Access Compliance Report

Public Rights-of-Way

(Curb Ramps)

Intersection ID: 47853	Main Street: EL_CAMPO_CT	Cross Street: STONE_PORCH_RD	Location: SW
ADA ID: 6BCCD598EB8A	Ramp Type: PerpDiag	Initial Pass/Fail: Fail	Overall Compliance: No
Severity Score: 35			
Codes/Mitigation Info/Possible Solution		Field Measurements/Component Compliance

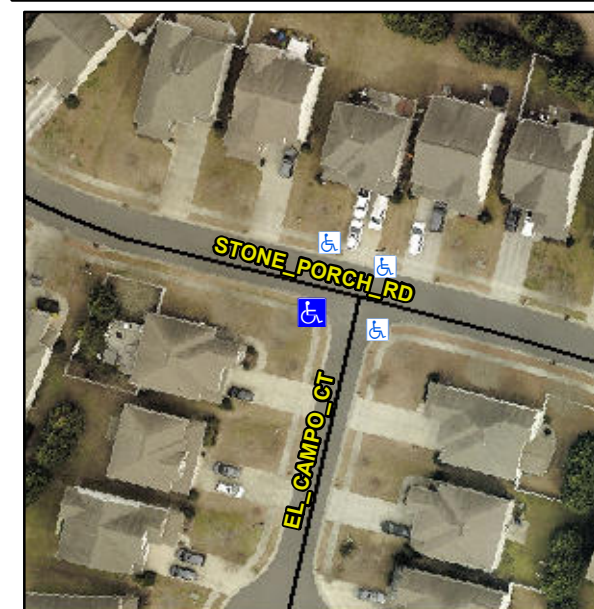
Not Found, R304.5.1, R304.2.2, R304.5.3

Compliance	Description	Data	Compliance	Description	Data
N/A	Ramp Length (in)	48.0	No	Ramp Slope (%)	12.0
No	Ramp Width (in)	45.0	No	Ramp XSlope (%)	2.9
N/A	Flare Type LT	N/A	N/A	Flare Type RT	N/A
N/A	Flare Slope LT (%)	N/A	N/A	Flare Slope RT (%)	N/A
N/A	Flare Traversable LT?	N/A	N/A	Flare Traversable RT?	N/A
N/A	Landing Length (in)	N/A	N/A	DWS Provided?	N/A
N/A	Landing Width (in)	N/A	N/A	DWS Contrast?	N/A
N/A	Landing Slope (%)	N/A	N/A	DWS Length (in)	N/A
N/A	Landing X Slope (%)	N/A	N/A	DWS Full Width?	N/A
N/A	Landing Curb? (Y/N)	N/A	N/A	DWS Offset (in)	N/A
N/A	Shared Landing?	N/A			
N/A	Gutter Ponding?	N/A	N/A	Gutter Slope (%)	N/A
N/A	Gutter Lip Ht (in)	N/A	N/A	Gutter X Slope (%)	N/A
N/A	Painted X Walk1?	No	N/A	Painted X Walk2?	No
	X Walk 1 Direction	To SE		X Walk 2 Direction	To NE
N/A	X Walk 1 Width (in)	N/A	N/A	X Walk 2 Width (in)	N/A
	X Walk 1 Slope (%)	1.3		X Walk 2 Slope (%)	2.7
	X Walk 1 X Slope (%)	0.8		X Walk 2 X Slope (%)	1.0

Remove & Replace Curb Ramp With Two New Directional Ramps or Equivalent.
